Land Use Final Decision

File number(s): DR 22-17 & SA 22-09

Through a Design Review application type, the applicant proposed site redevelopment of a motel site developed in 1986 and presently occupied by the La Quinta Inn & Suites by Wyndham Woodburn motel through addition and remodel into a Holiday Inn Express (HIEX) of 84 rooms with 86 off-street parking spaces and with site upgrades including landscaping and wide walkways to public sidewalks.

Street Adjustment SA 22-09 was to keep the Arney Road landscape strip 6 inches narrower than the standard, that is, 5.5 feet (ft) including curb width instead of 6 ft including curb width.

HIEX WOODBURN ADDITION
 WOODBURN, OREGON
 SITE PLAN

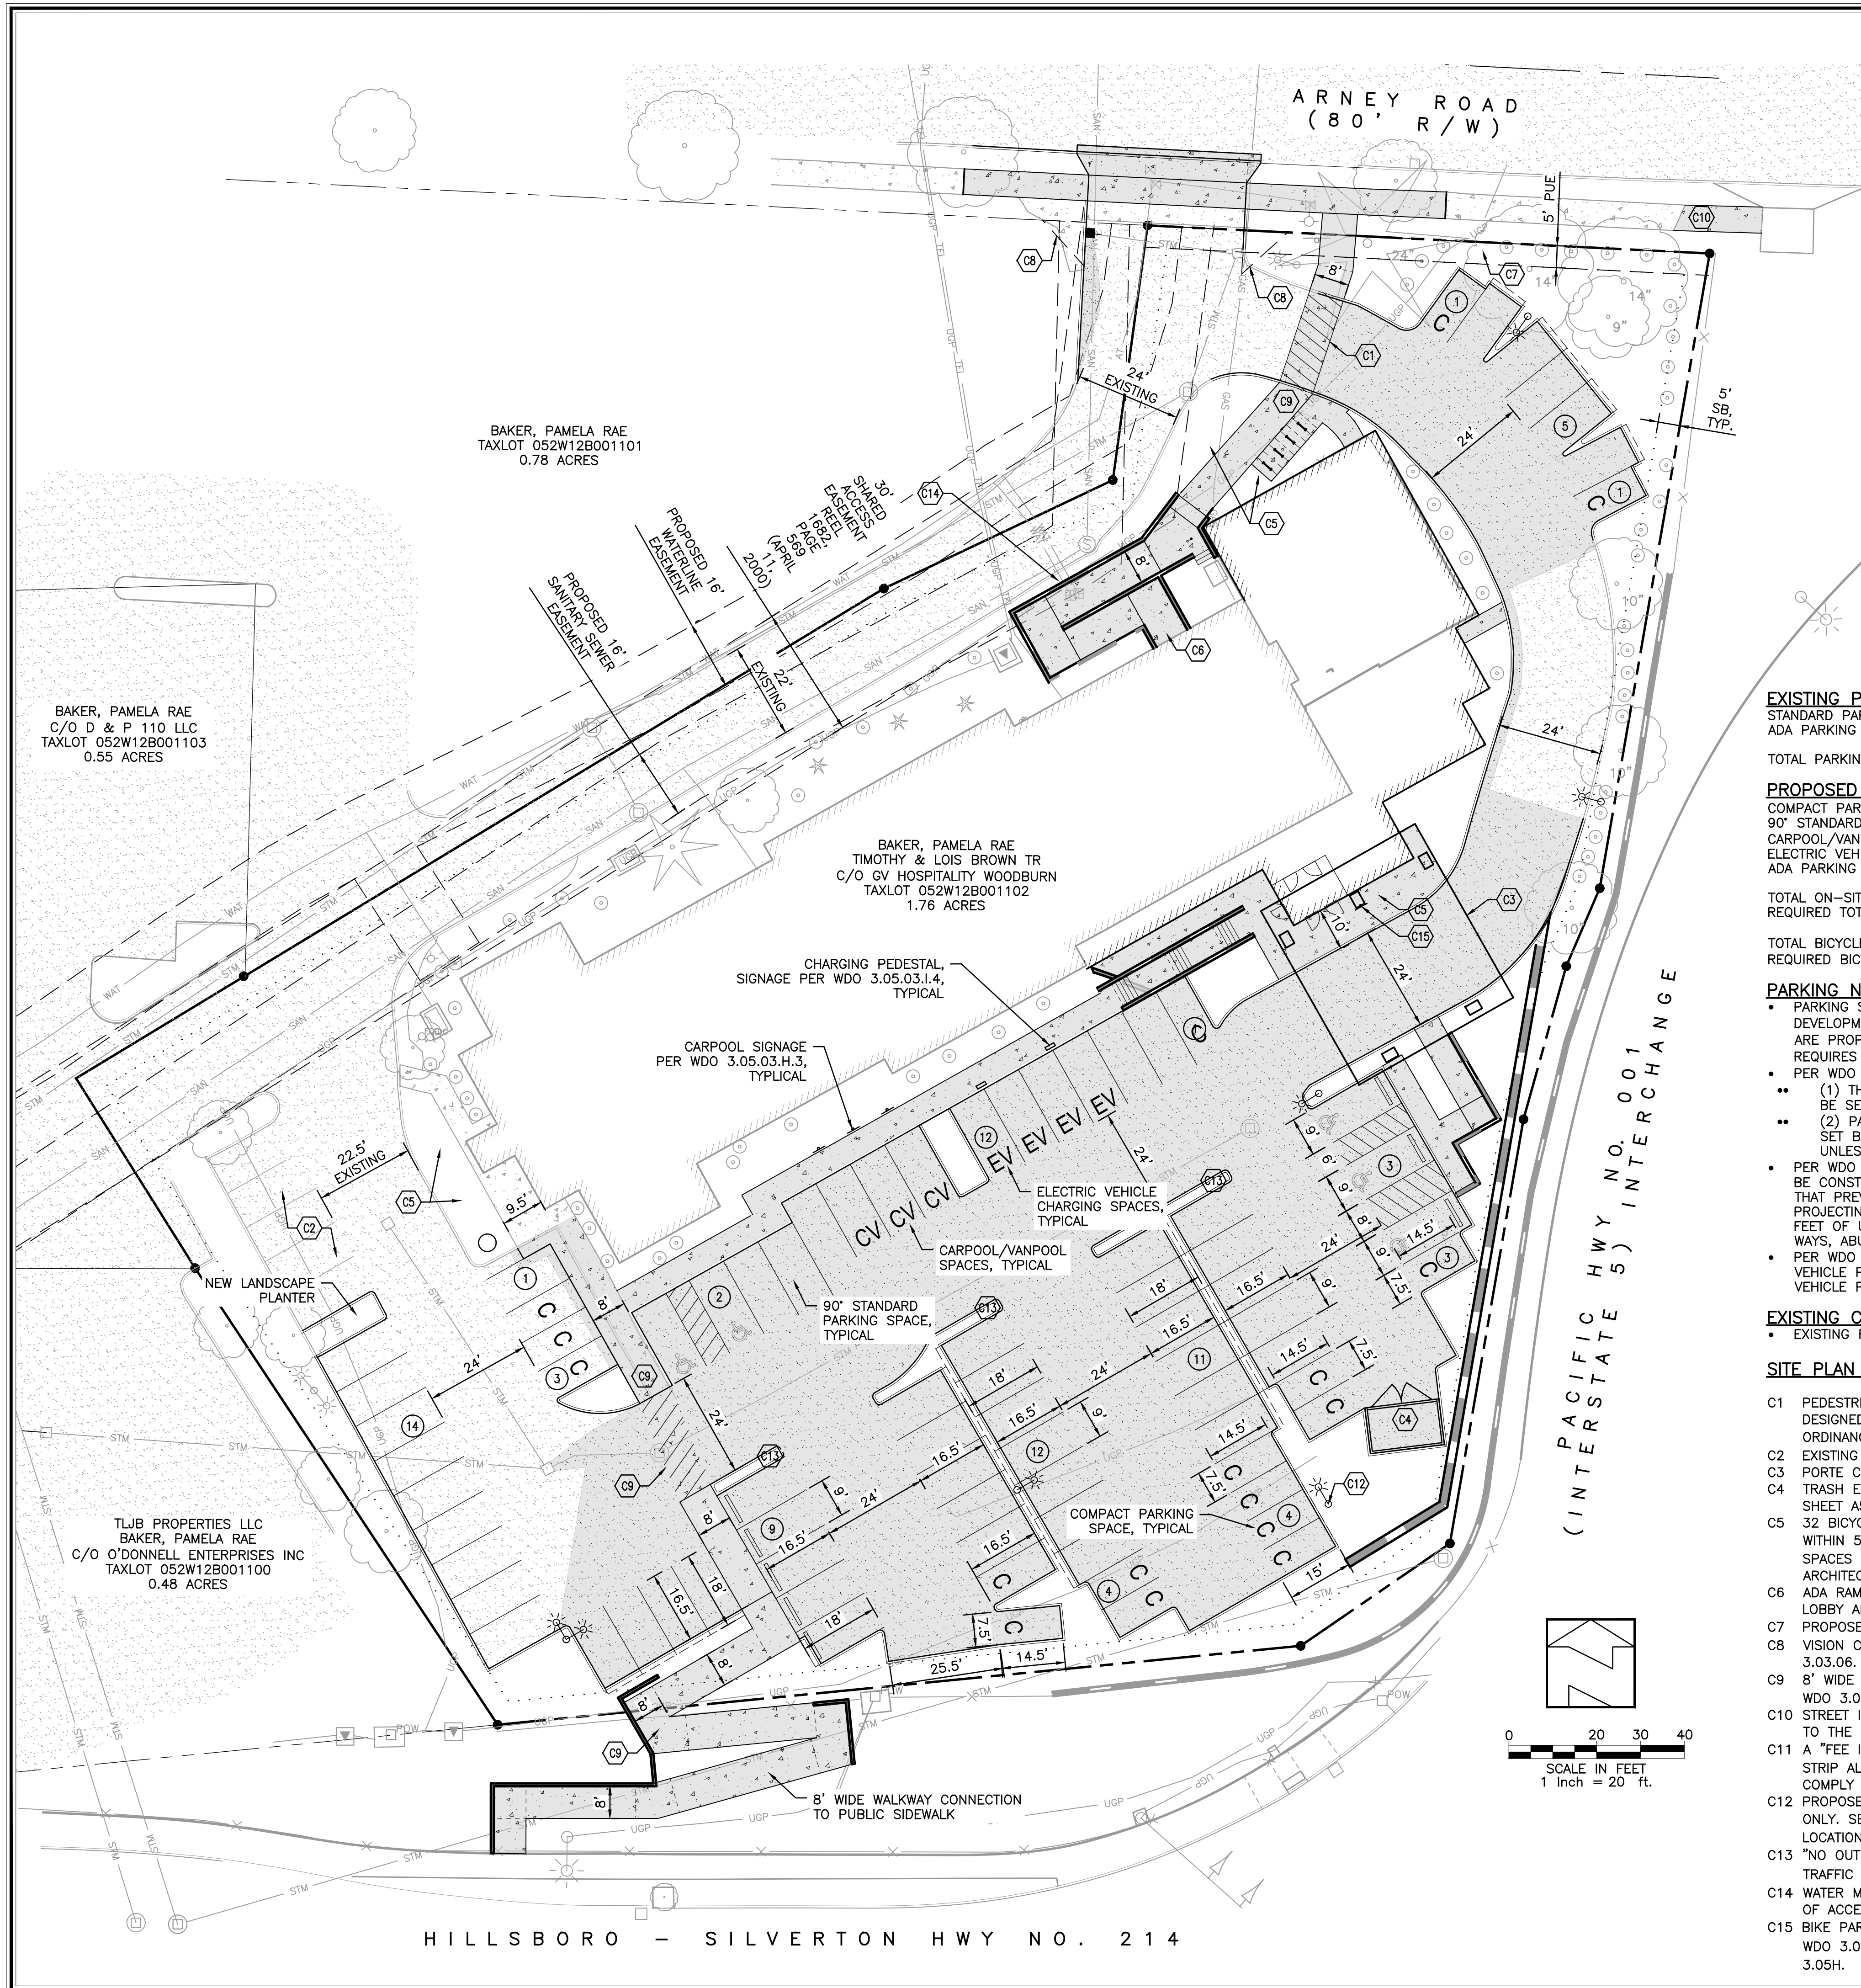
D2. Driveway max width: To conform with WDO Table 3.04A maximum regarding paved width of two-way driveways in a commercial context, the developer shall revise the site, composite utility, and landscape plans – or equivalent sheets within a building permit application plan set through the Building Division and/or a civil engineering review application civil plan set through the PW Engineering Division (and/or ODOT if and as applicable) – either to illustrate and dimension the approach, apron, curb cut, or ramp of the Arney driveway at max width 24 ft or, if having a left turn pocket, then 36 ft; or, to document if and how Table 3.04A footnote 7 about Woodburn Fire District (WFD) OFC administration is applicable. For the latter, documentation shall include at least either (a) a letter or equivalent from WFD or (b) revision of fire access plan Sheet P220 to narrow the driveway to that necessary to accommodate illustrated fire apparatus turning radius and to dimension the narrowed driveway apron. If through building permit review, then this is due prior to issuance, or if through civil engineering plan review, then due prior to PW (or ODOT) issuance of an approved civil plan set.

D3. Walkways: To conform with WDO 3.04.06D.2, the walkway crossing of the drive aisle near the main guest entrance and ADA parking shall be striped with any of hatch or ladder pattern or three or more bars perpendicular to the crossing. The developer shall revise site plans prior to building permit issuance.

D4. Wheel stops: To conform with WDO 3.05.02H, the developer shall revise the site plans prior to building permit issuance and install wheel stops in the two compact parking stalls along the highway wide walkway north end.

D6. Double-striping: To conform with WDO Figure 3.05C, the developer shall revise the site plans prior to building permit issuance and double-stripe parking stalls.

**HIEX WOODBURN ADDITION
WOODBURN, OREGON
PRELIMINARY LANDSCAPE PLAN**

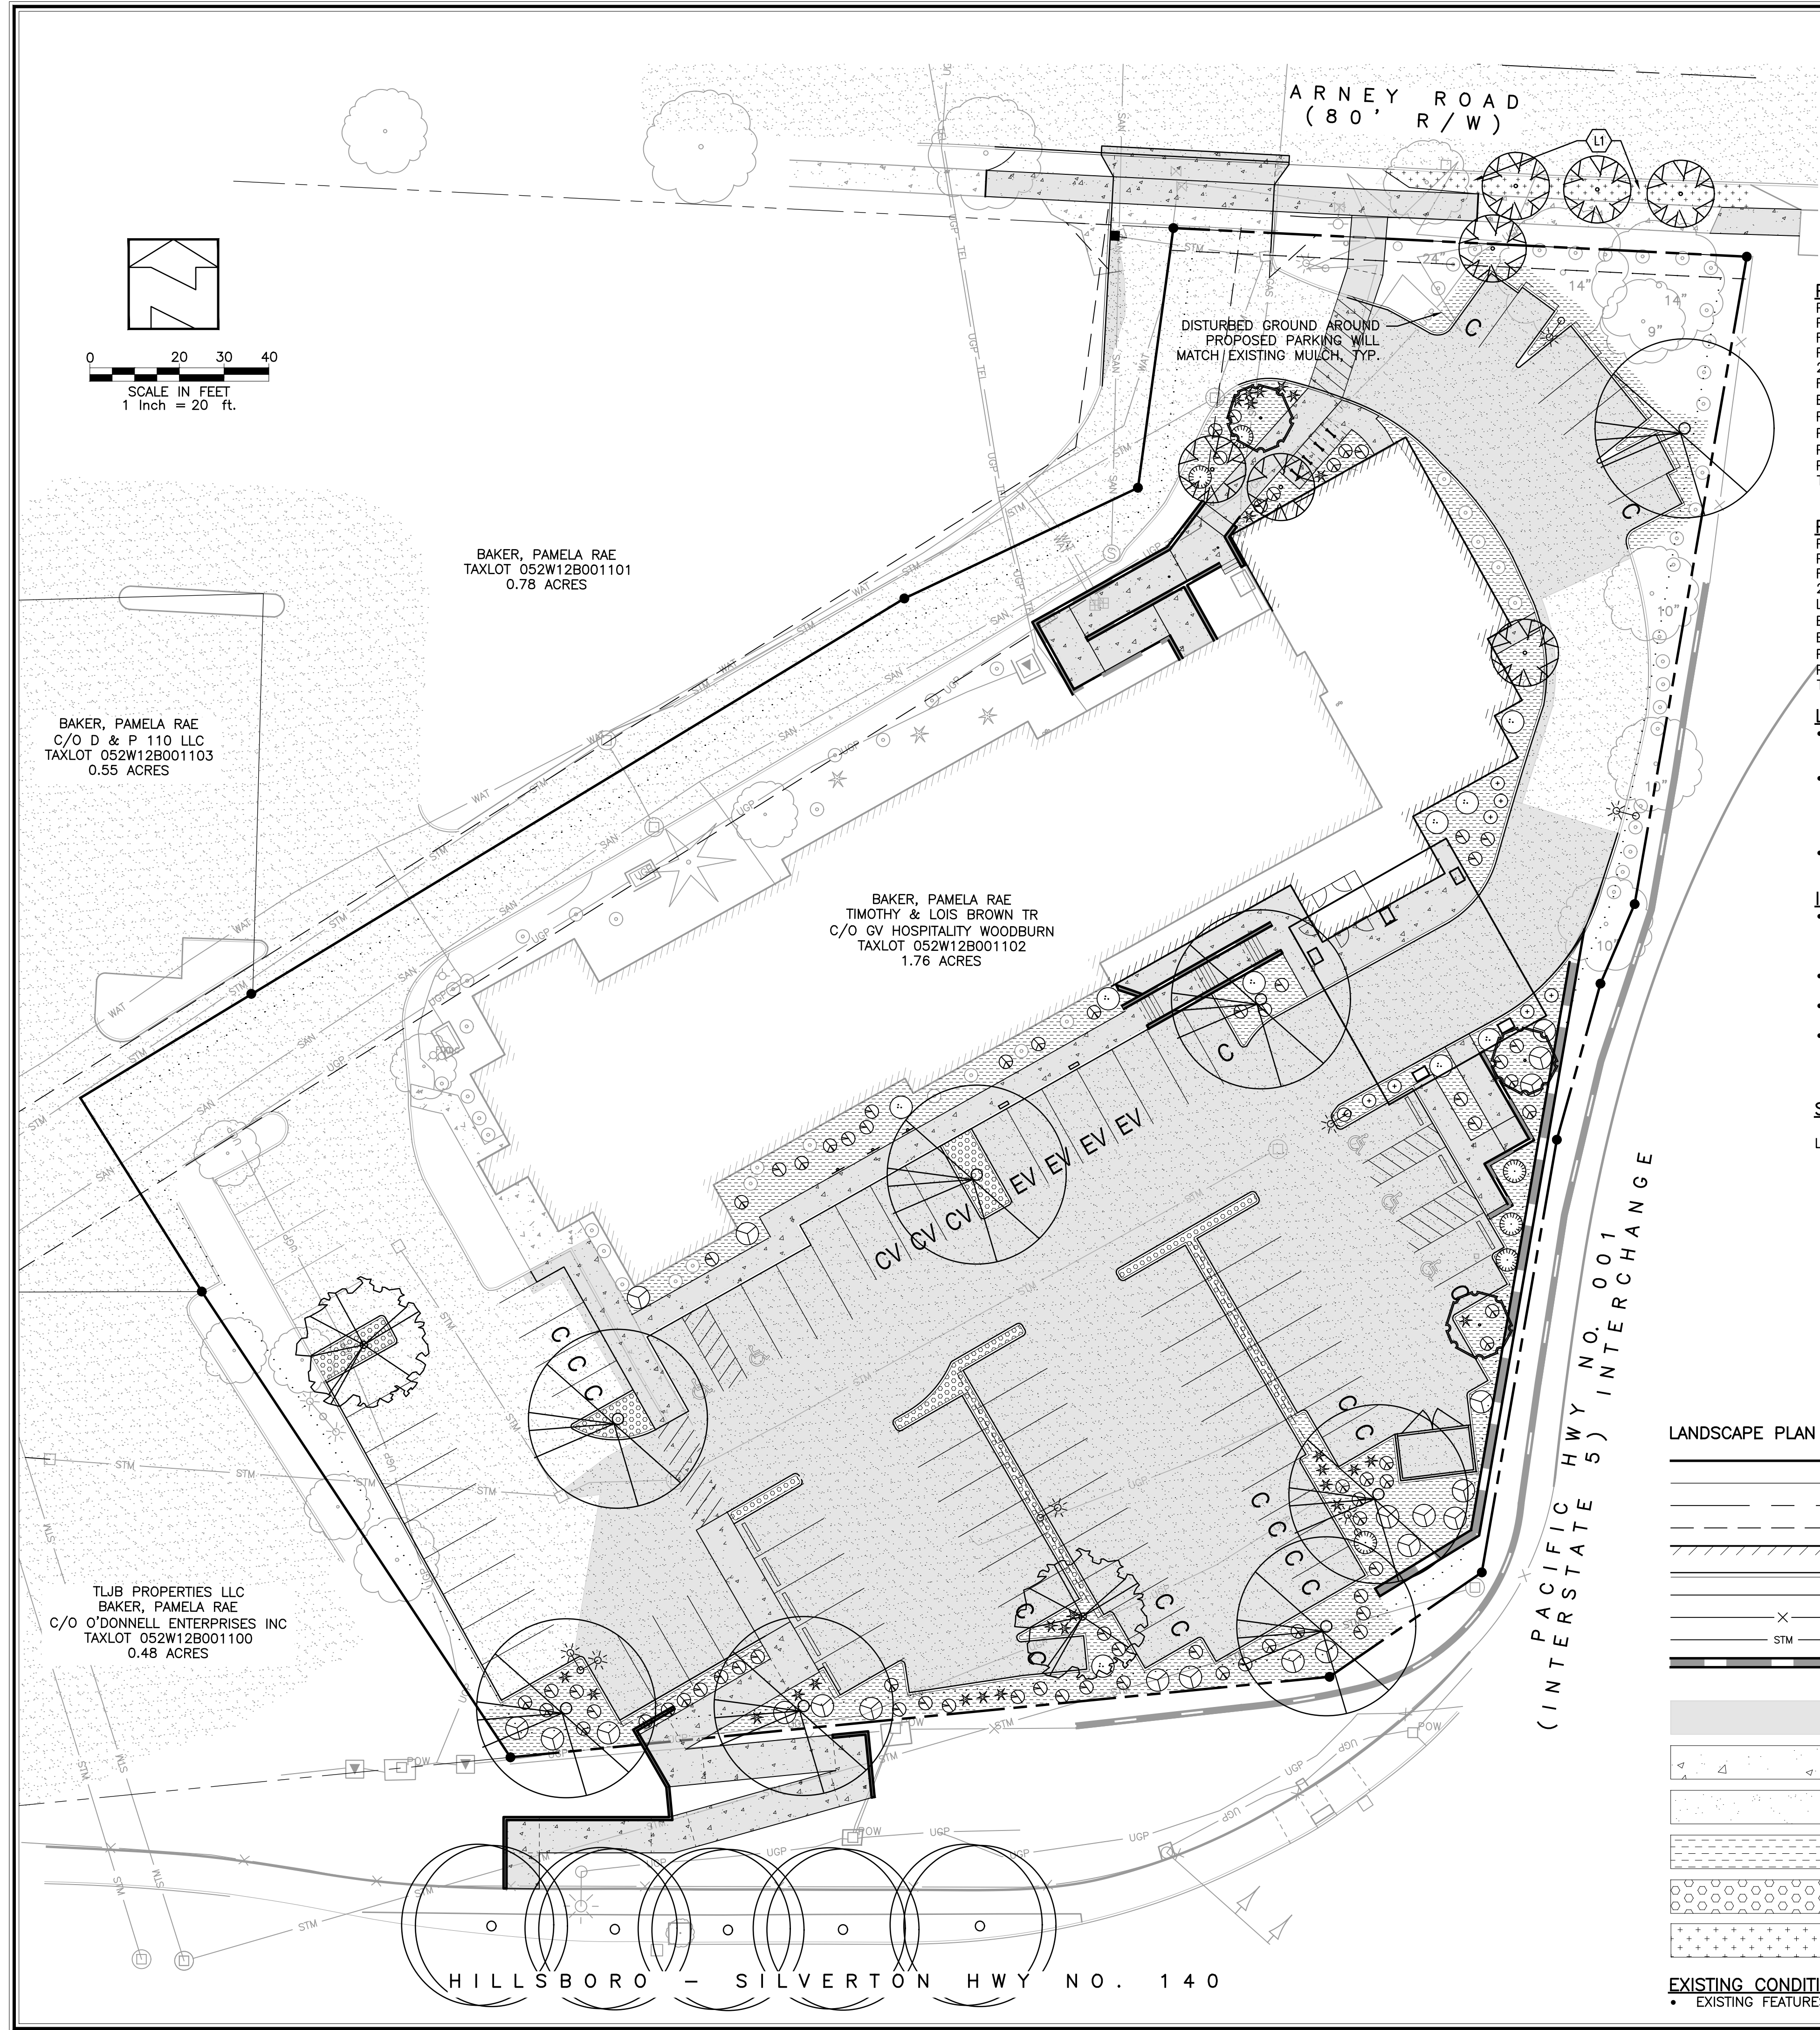
- b. Significant tree:
 - (1) To conform with WDO 3.06.07, the developer shall revise the site, composite utility, grading, and landscape plans to note protection of the 24-inch cedar tree during construction of Arney wide walkway to its west and additional parking to its east.
